REPORT ON THE "ALISO CANYON FAULT"
AND THE ALLEGED "MOUNTAIN TOP FAULT ZONE"
CAMP PENDLETON, CALIFORNIA

November 25, 1981

SOUTHERN CALIFORNIA EDISON COMPANY AND
SAN DIEGO GAS AND ELECTRIC COMPANY

RESPONSE TO QUESTIONS

FIGURE 1.1 - Spatial distribution of relative locations. The largest and best located event ($M_L=3.0$, Nov. 7, 11:42 GMT) was used as the master event.

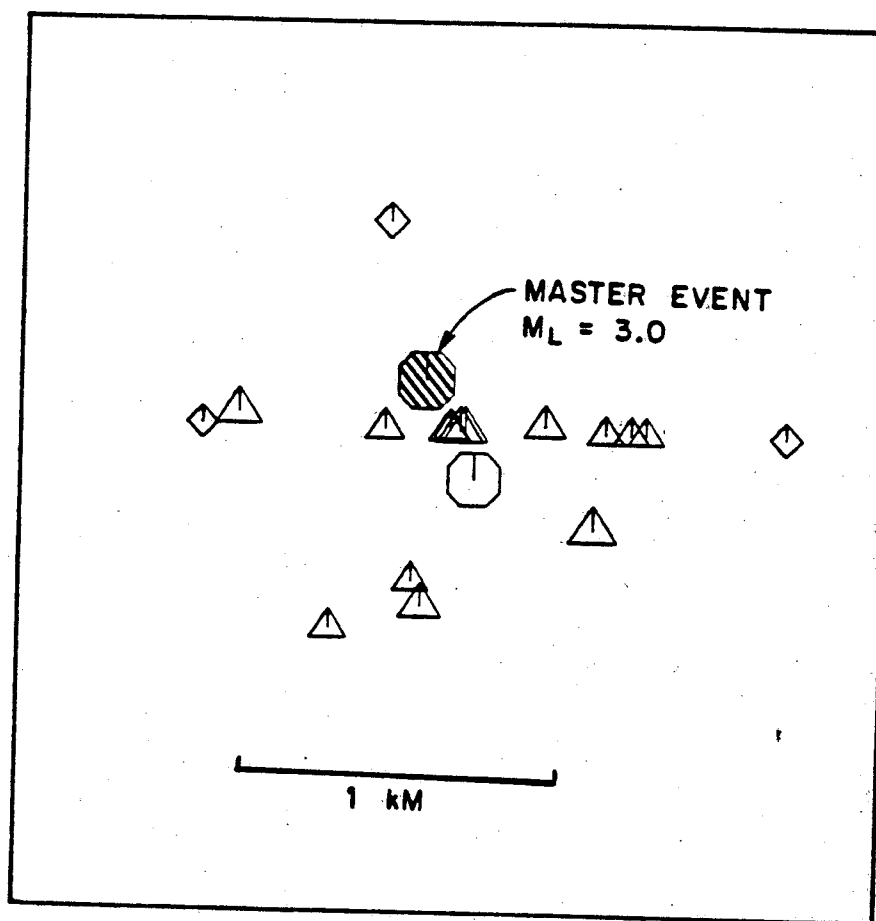
1. How reliable are the locations for the 20 earthquakes?

a master event. In the normal process of locating an earthquake (used above) the computer program starts the location beneath the first station that recorded seismic energy. The location is then iteratively refined until the RMS errors of the observed minus the calculated travel-times, to all seismic stations, is minimized. For the present swarm, with a tremendous range in the quality and quantity of phase data from event to event (eg., 111 phase data for the $M_L=3.0$ and only 6 phase data for the $M_L=1.3$ event), this procedure will result in a false impression of the true spatial dimensions of the swarm. In a relative location the computer starts the iteration process from a master event (we used the best located event: $M_L=3$) and determines how far each earthquake must be offset to satisfy the data. Figure 1.1 shows the resulting relative locations. Note that all 20 events are located within about 1 km of the master event.

In conclusion, the swarm surrounds the largest event with a radius of about 1 km. The location of the largest event ($M_L=3$) is:

Considerations of the velocity model, the station distribution, the numerous phase data, and the formal statistical error for the largest event, all suggest a horizontal uncertainty of 1 km.

FIGURE 3.2

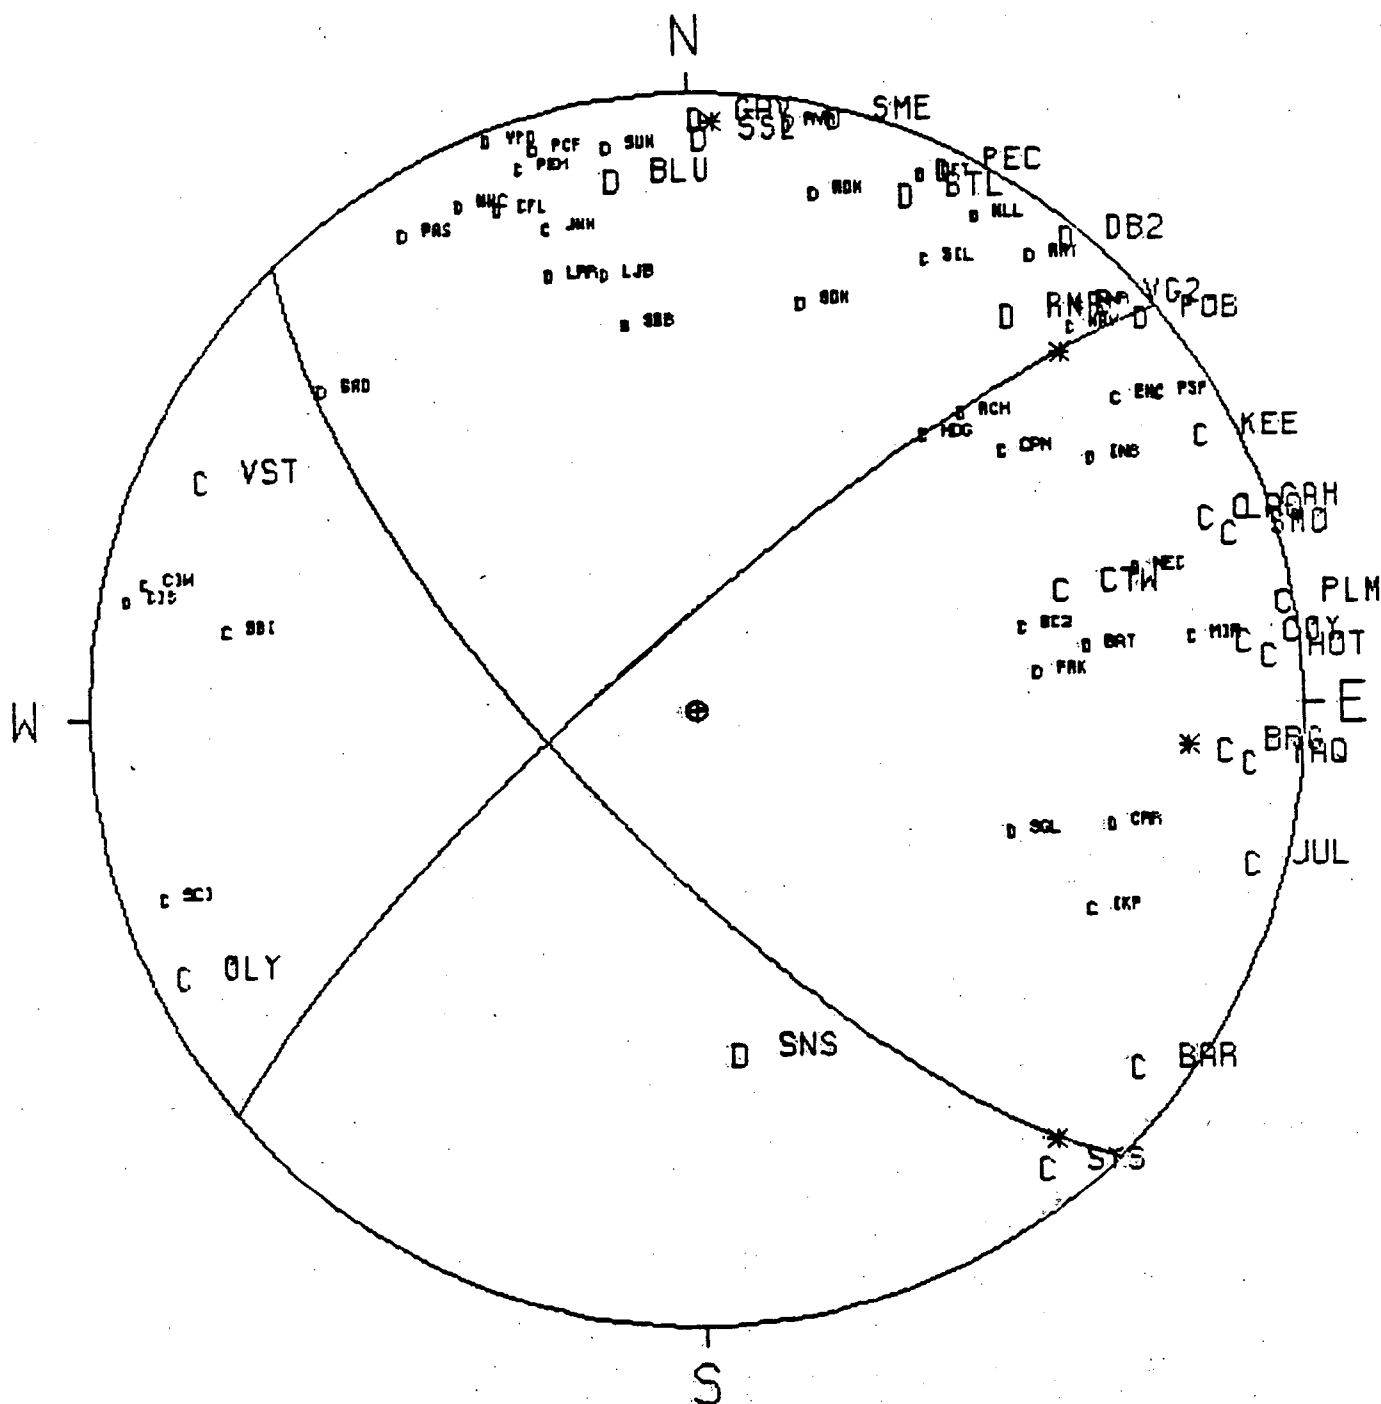
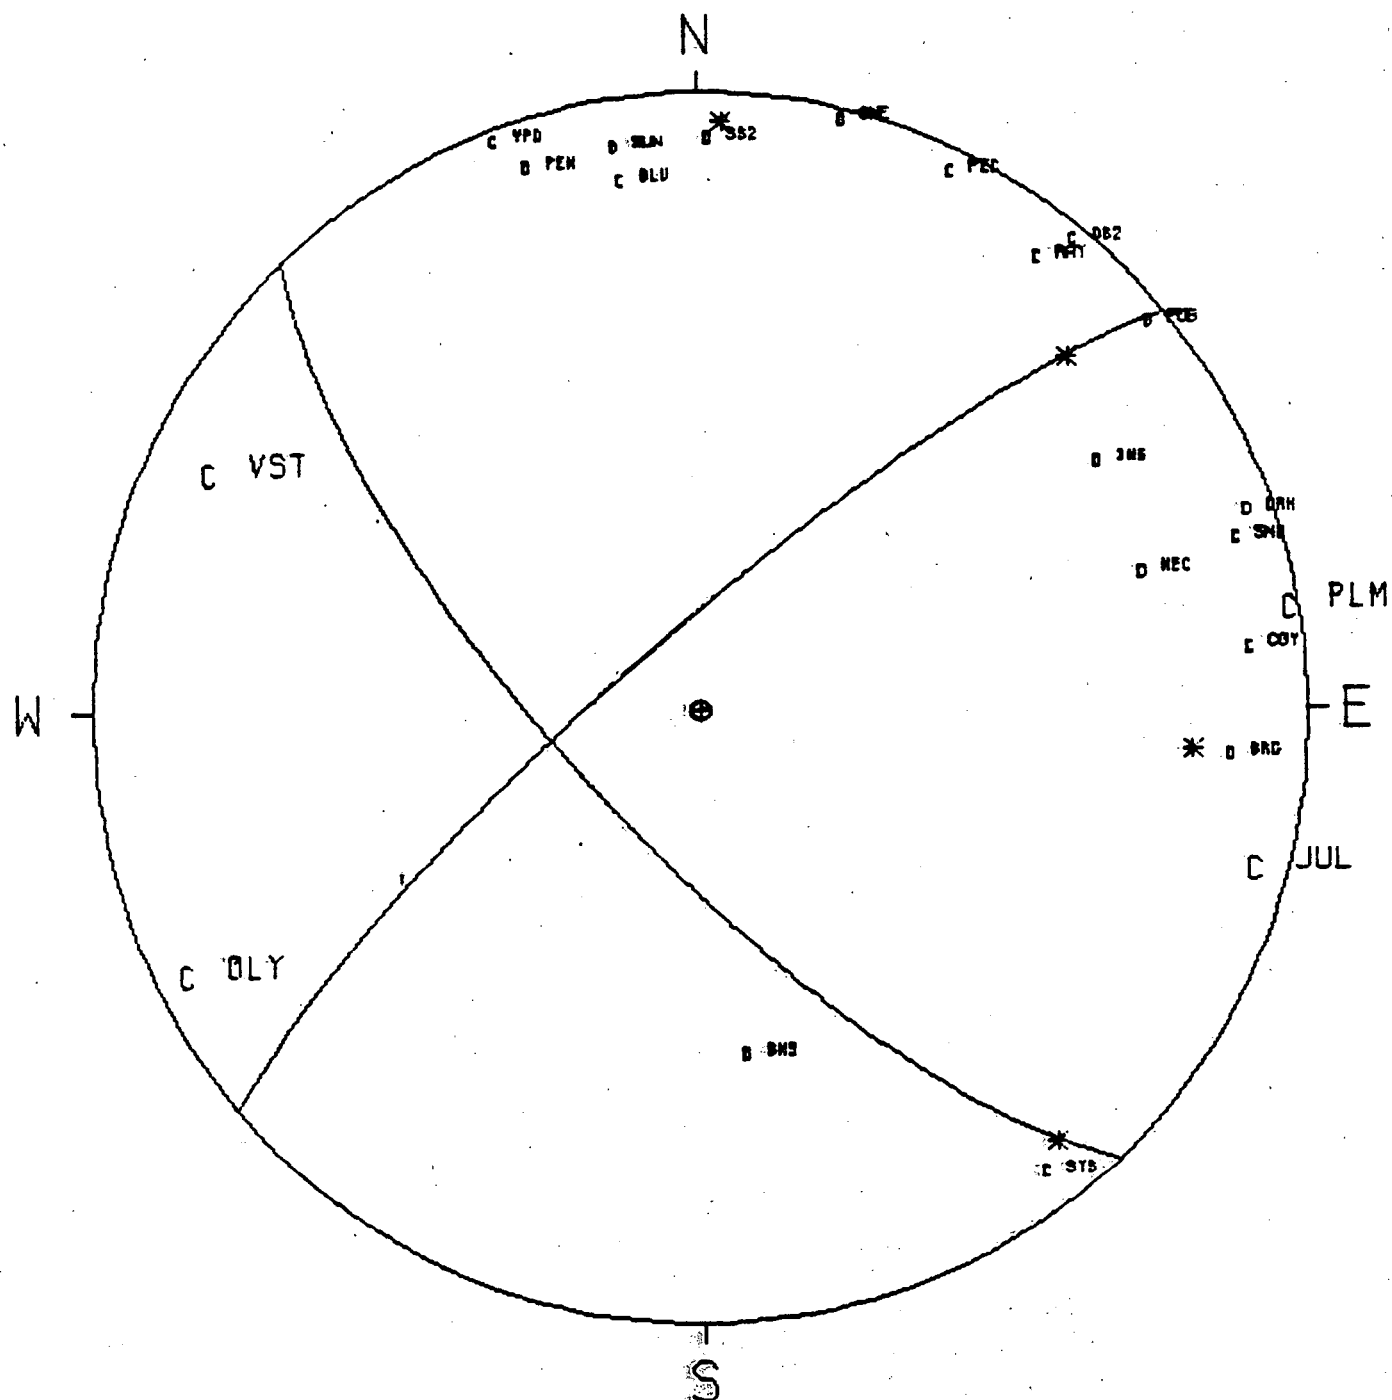
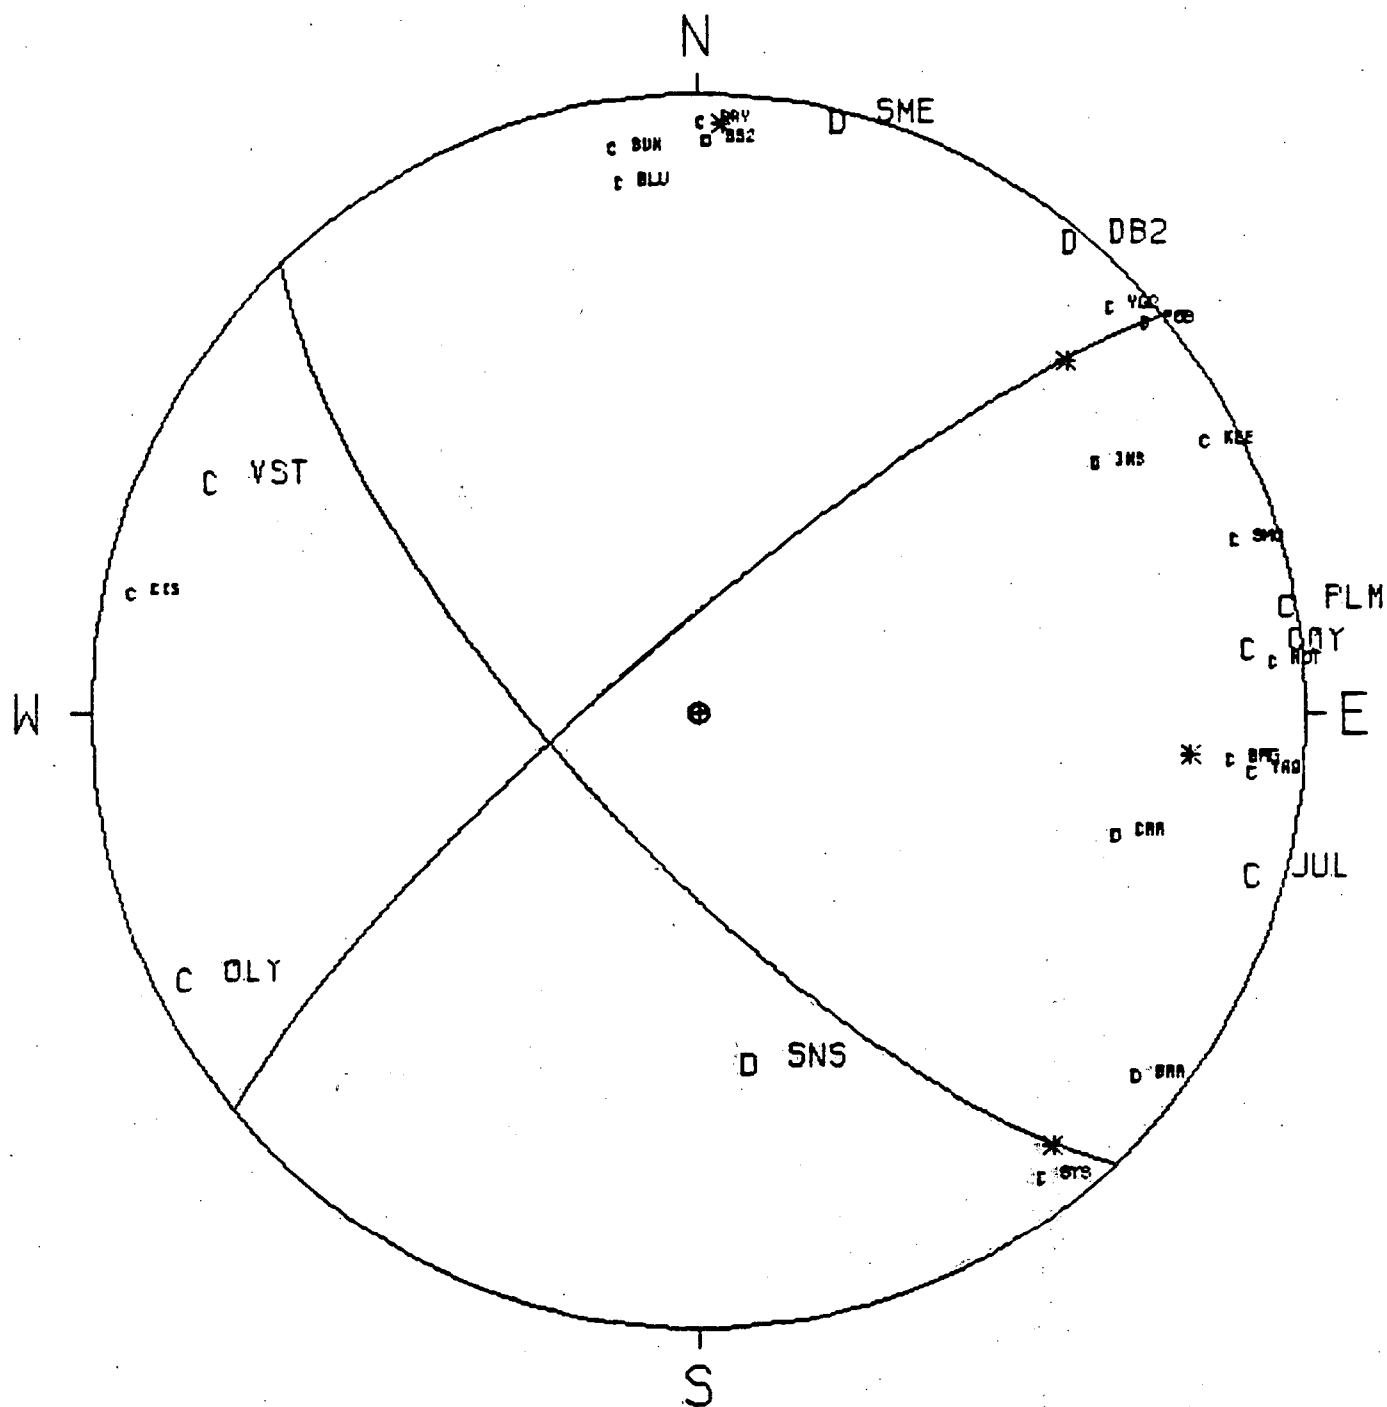
3. Describe the first motion data for the five largest events.

All of the first motion data for the five largest events are plotted on Figures 3.1 to 3.5 and tabulated in Tables 3.1 to 3.5. The size of the "C" and "D" symbols on the figures (large and small) correspond to impulsive or emergent arrivals, respectively. The abbreviations over the columns in the tables have the following meanings: STA = station; DIR = compression or dilatation; QUAL = Quality, 2-impulsive, 1-emergent; DIST = distance, km; EVAZ = azimuth from event to station; TOA = take-off angle; X and Y = position in inches from the center of focal plot for plotting station (assumes a 4-inch radius plot).

The best constrained event occurred on Nov 7, 1981 at 11:42 GMT ($M_L=3$), Figure 3.2. The other 4 events are consistent with this mechanism. However, with the exception of the Nov 9, 00:47 GMT event, Figure 3.5, the mechanisms are not constrained. To evaluate the consistency of the observations, the mechanism from the $M_L=3$ event has been plotted on all five figures (3.1-3.5). This mechanism is consistent with all of the impulsive (QUAL = 2) arrivals and most of the emergent, or questionable, polarities.

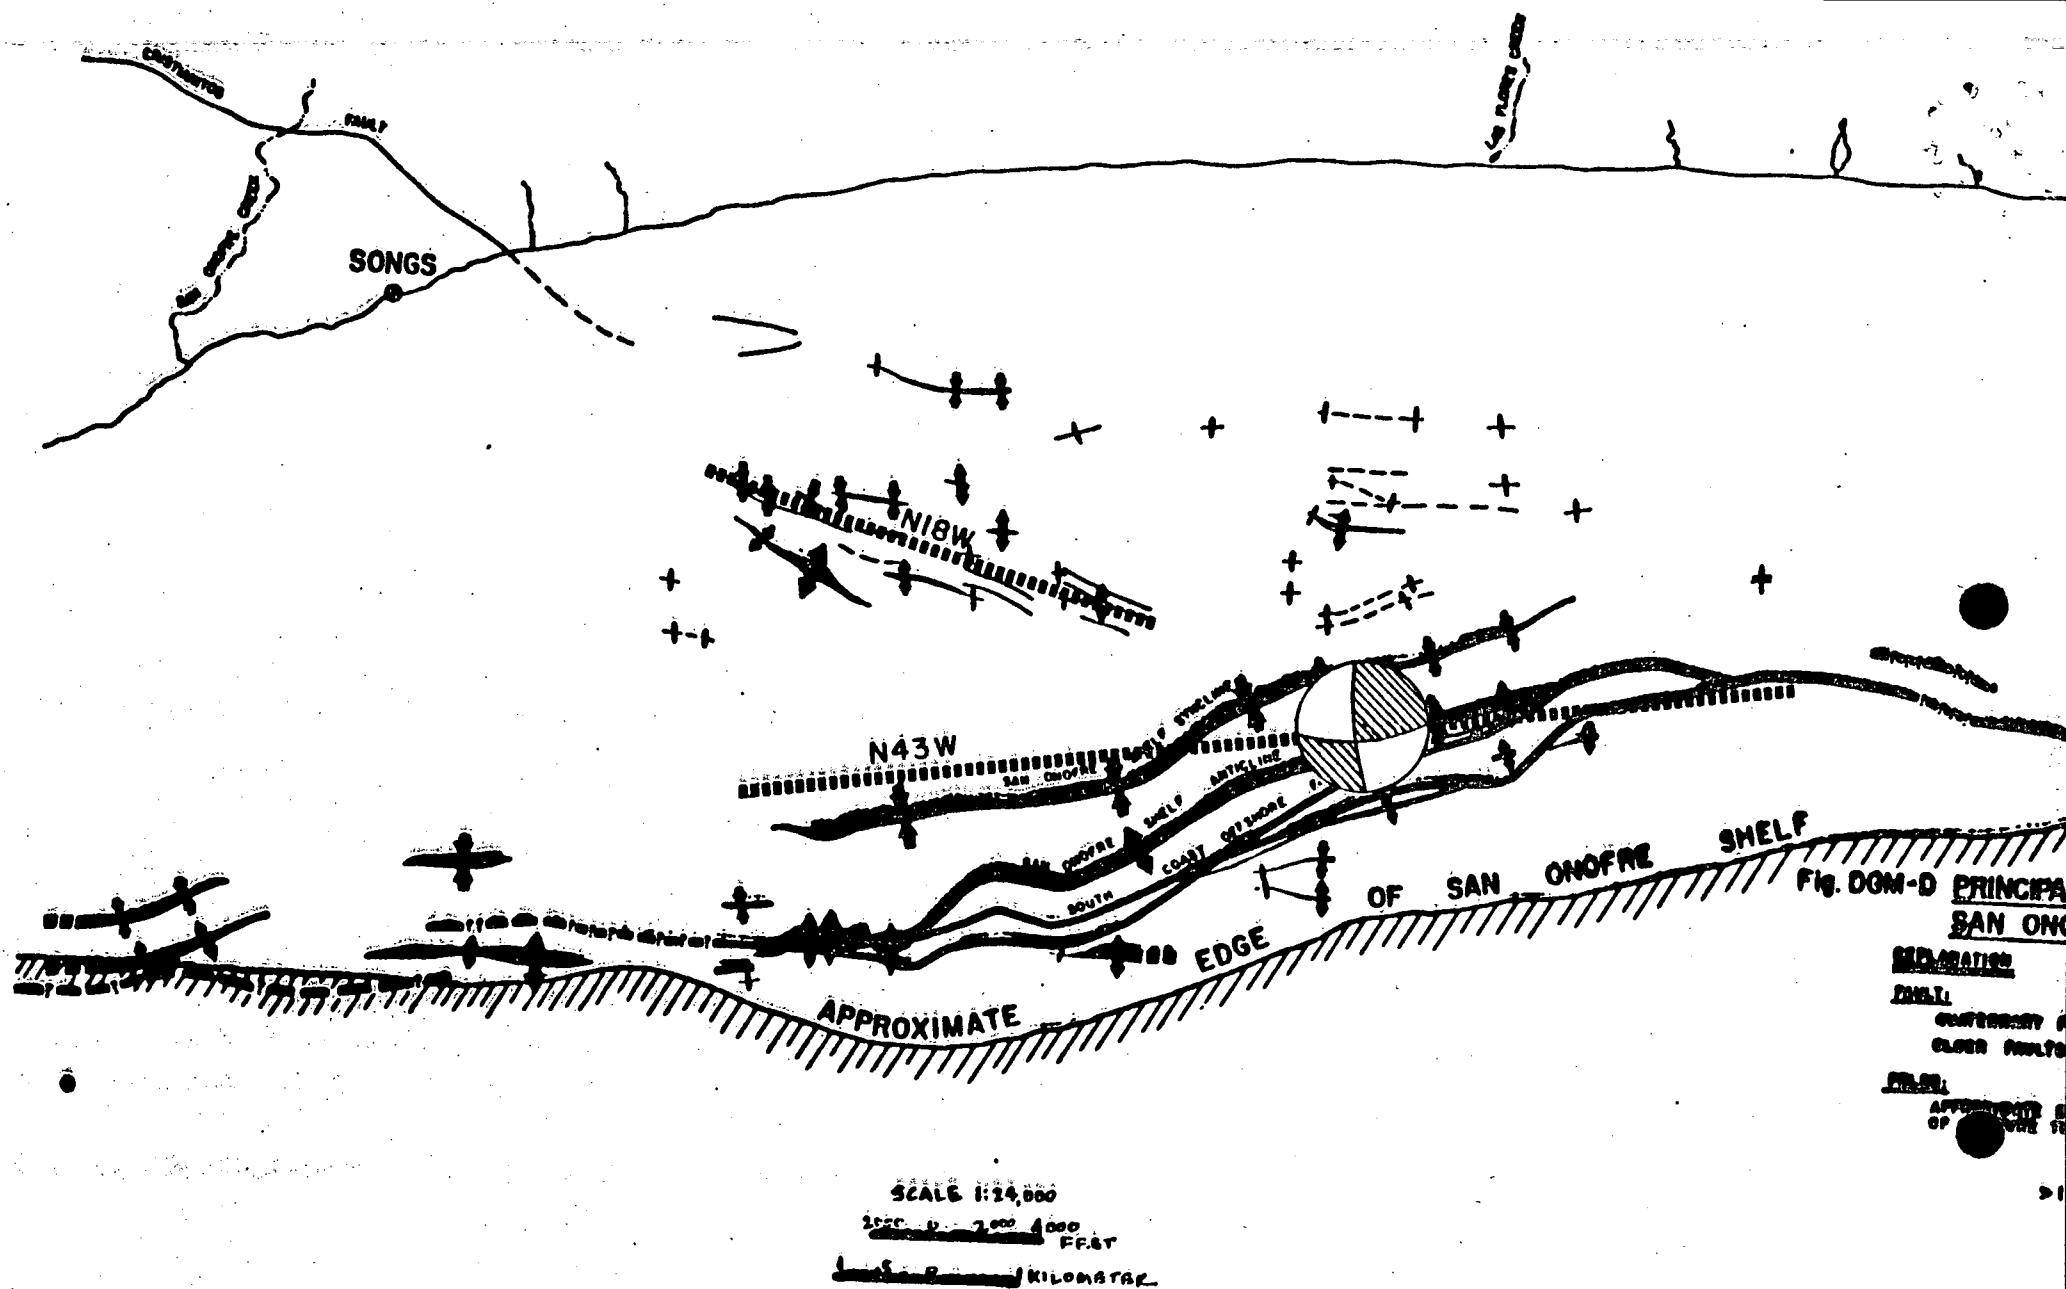
13. What observations can be made concerning the CZD and the swarm if the Greene and Kennedy map is representative of the geologic conditions?

The fault plane orientation and the location of the recent swarm is shown on Figures 13.1 (Moore) and 13.2 (Greene and Kennedy). The center of the focal mechanism has been plotted at the epicenter of the best located event ($M_L=3.0$). The horizontal uncertainty for this location is about 1 km. The radius of the mechanism corresponds to the dimensions of the swarm as determined in the relative location analysis discussed

in the response to Question 1. The strike of the northwest trending plane ($N43^{\circ}W$) is nearly parallel to the OZD (Horizon C) and oblique to the general $N18^{\circ}W$ trend of the Greene and Kennedy CZD.

On the basis of the spatial association of the swarm with the OZD, the consistency of the determined strike of the focal mechanism with the OZD, and the disagreement of the mechanism with the sense of motion of the old faults located east of the OZD, applicants conclude that the Nov. 6-9- 1981 swarm was associated with the OZD. This location of the swarm and the orientation of the focal mechanism does not controvert the extensive geological and seismic investigations of the offshore region.
